Architectural Review Board

August 23, 2022 – 5:30 p.m.

III. Full Review of Items

4F

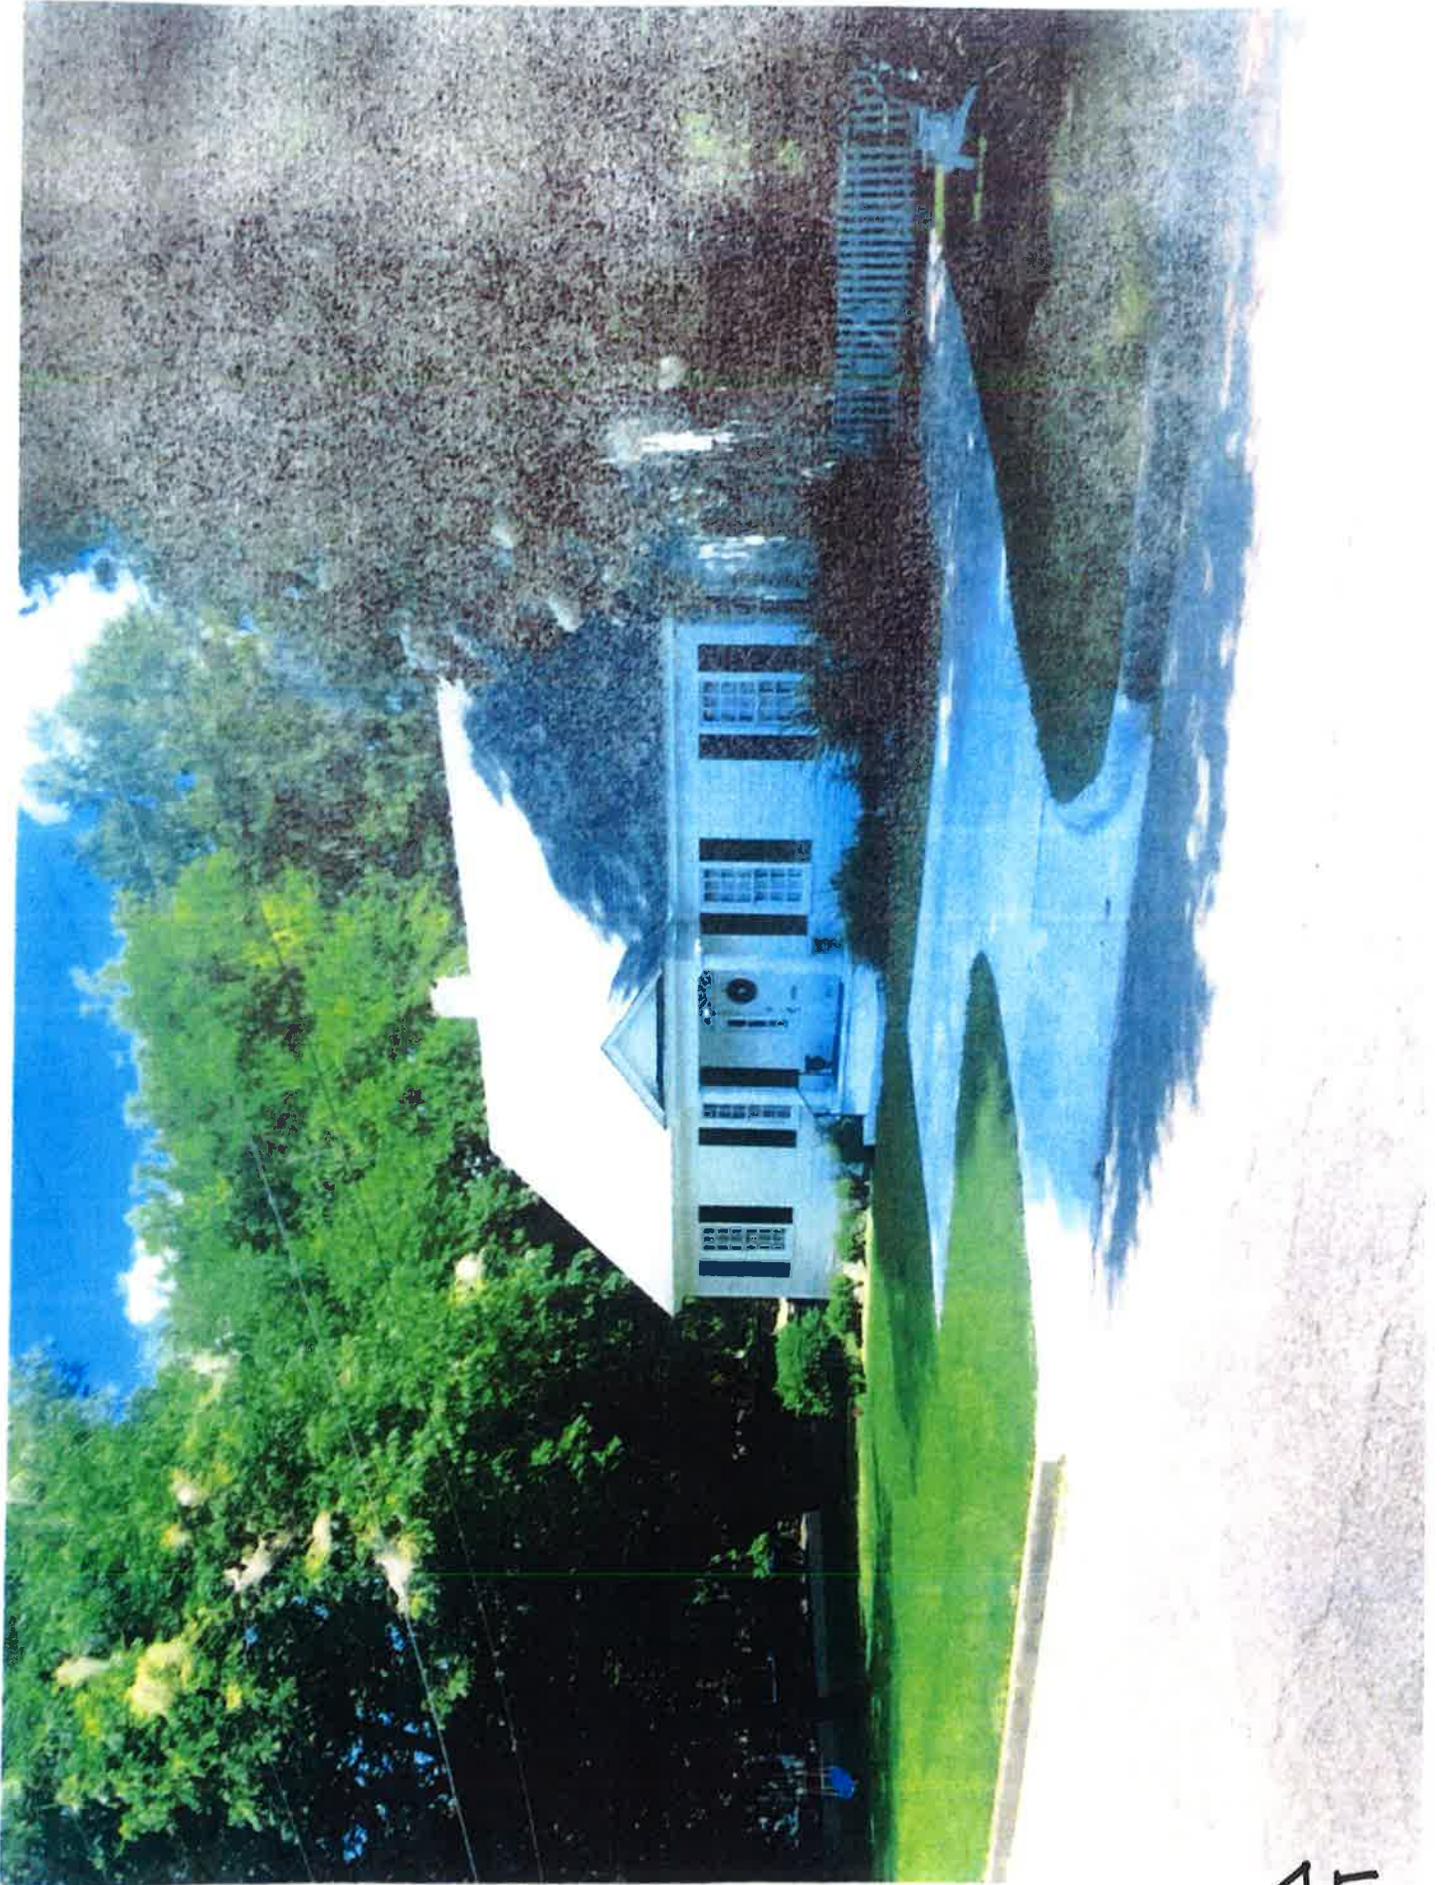
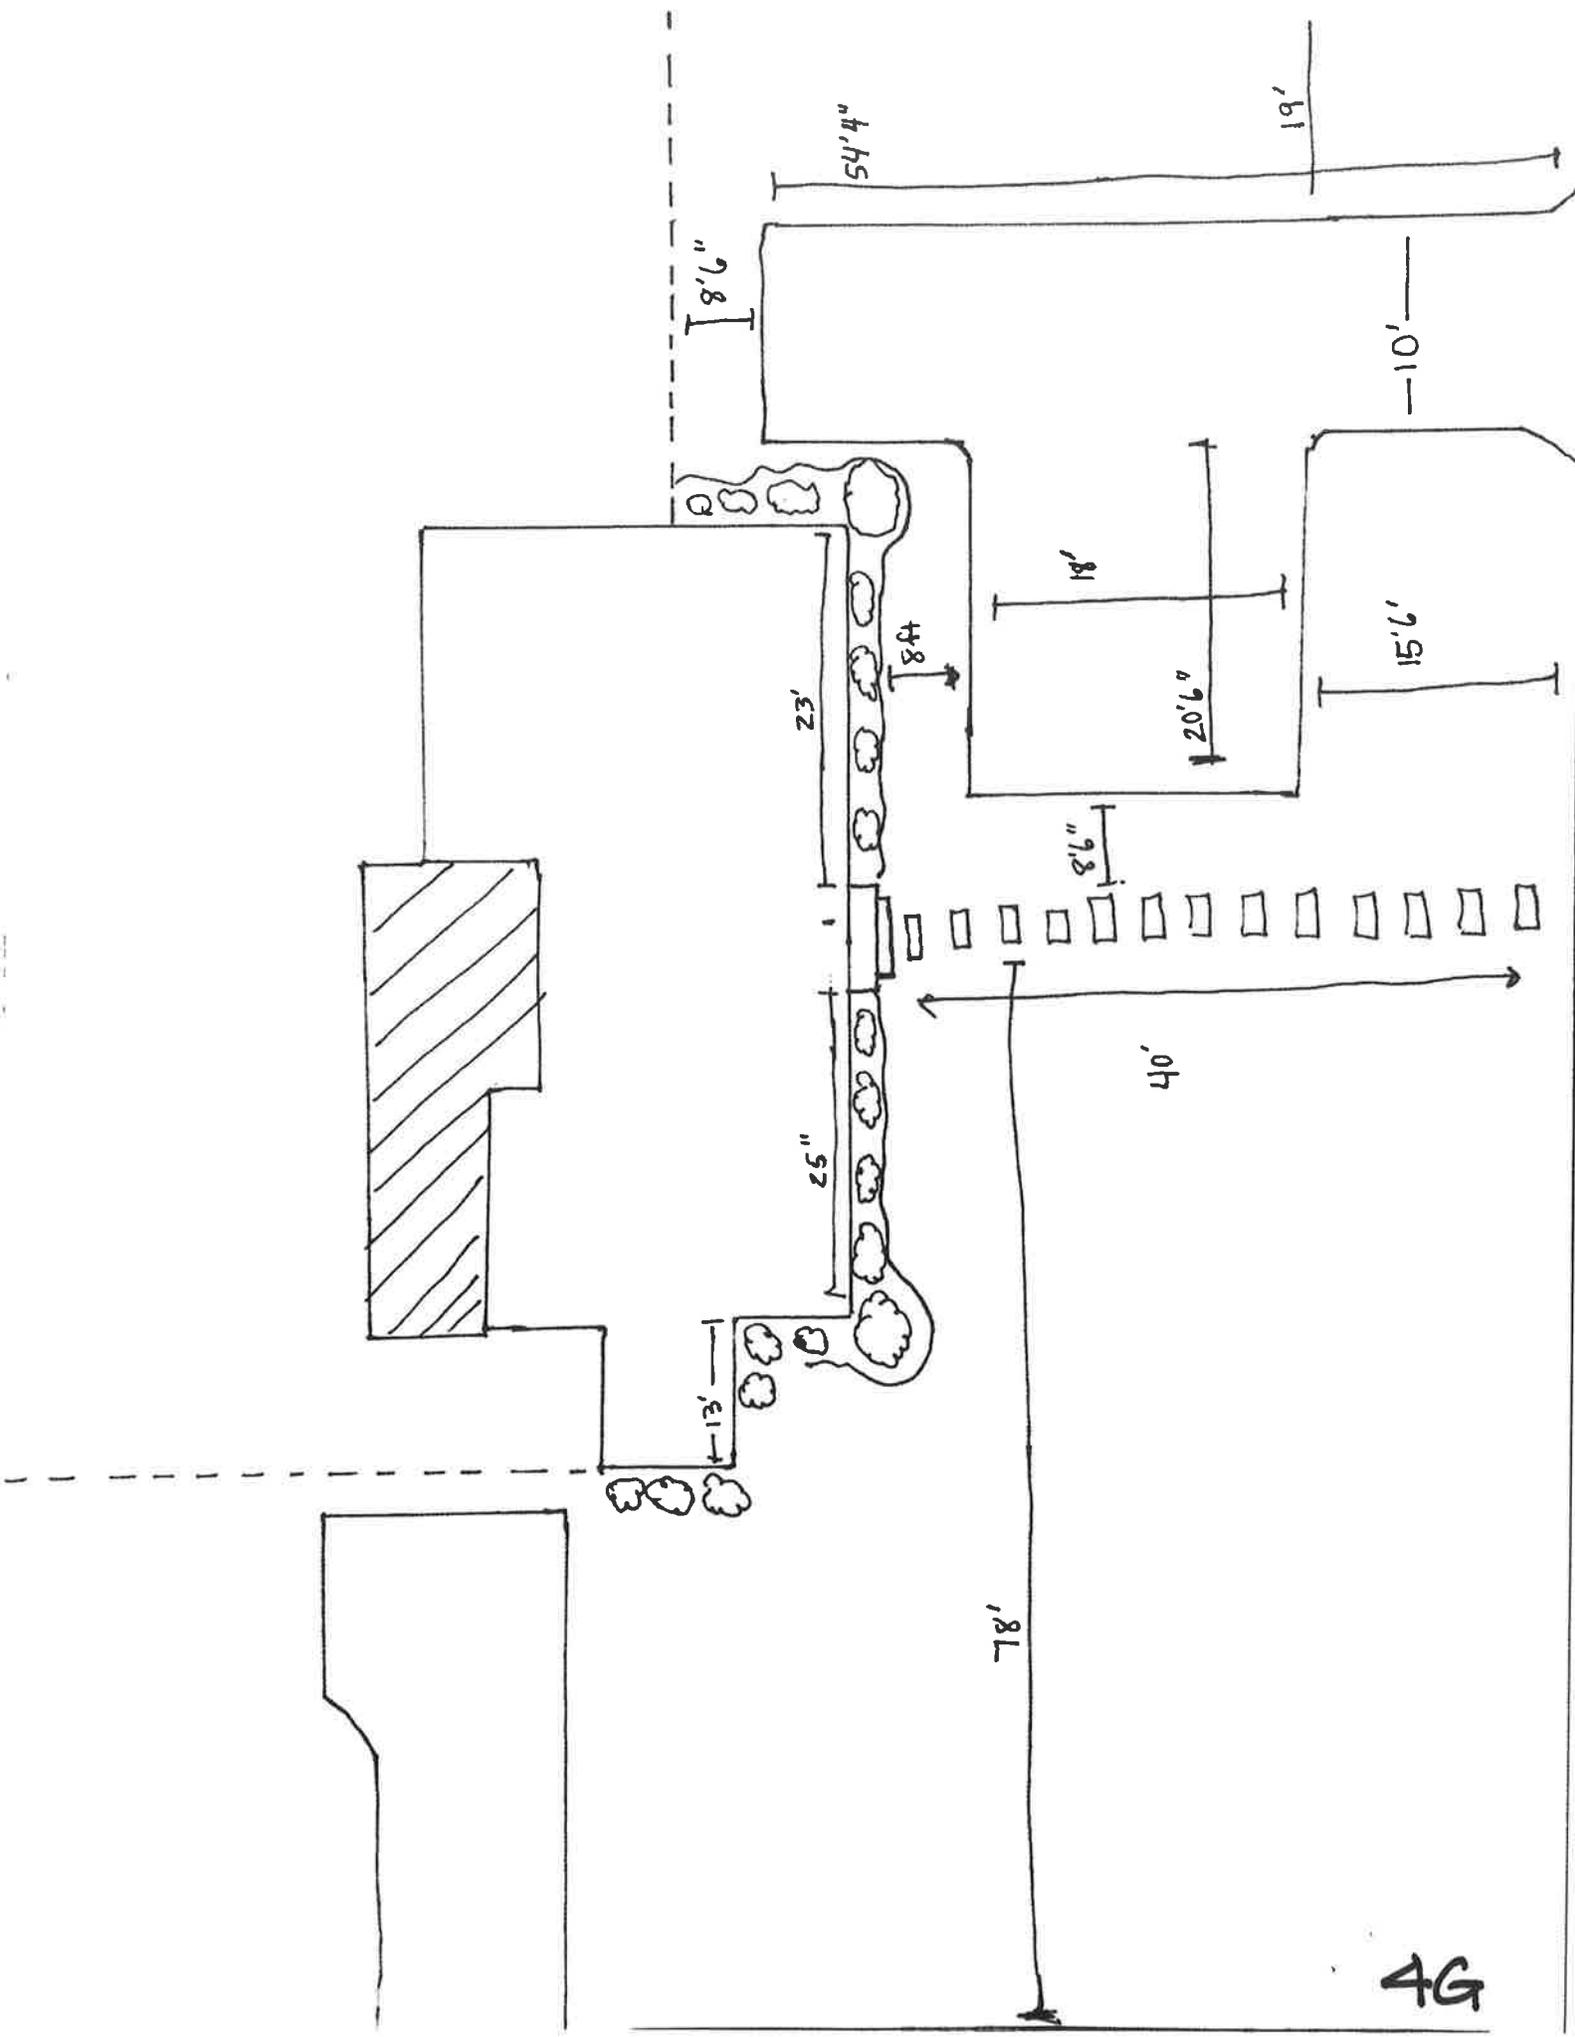
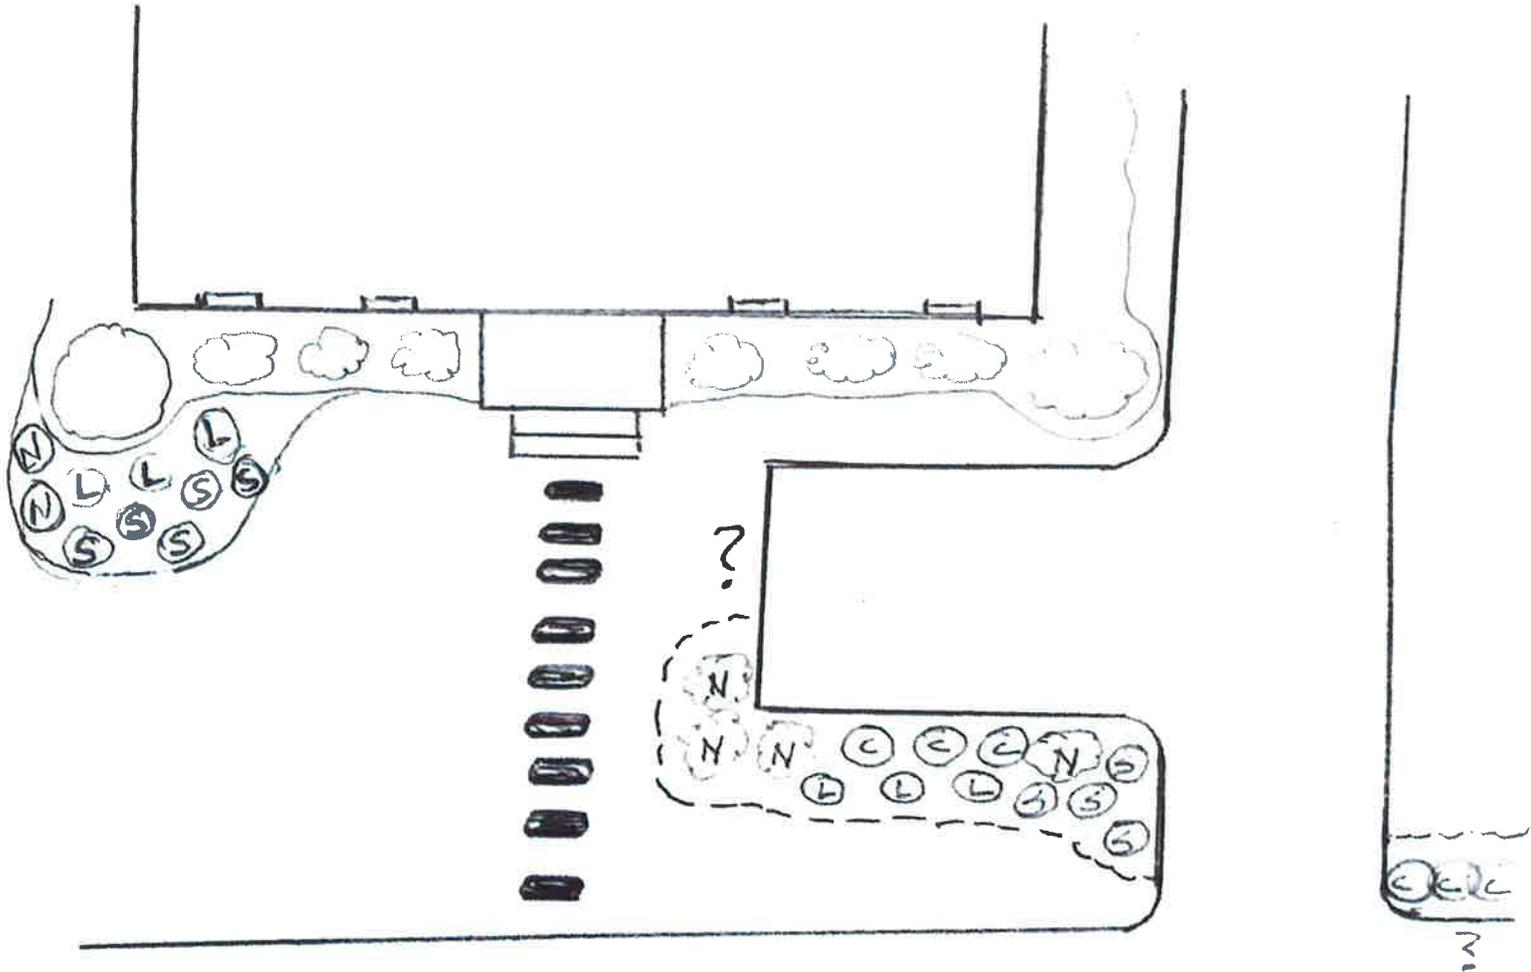
- As with any request for approval after the fact, the question the Board needs to ask itself is would we have approved this request had it been made prior to work being done.
- UF: The size and number of shrubs should screen the parking.
- The ROW in the front yard is approximately 20’, new plant material in the ROW requires approval from the Urban Forester. UF is okay with the plant material if it’s approved by the ARB.
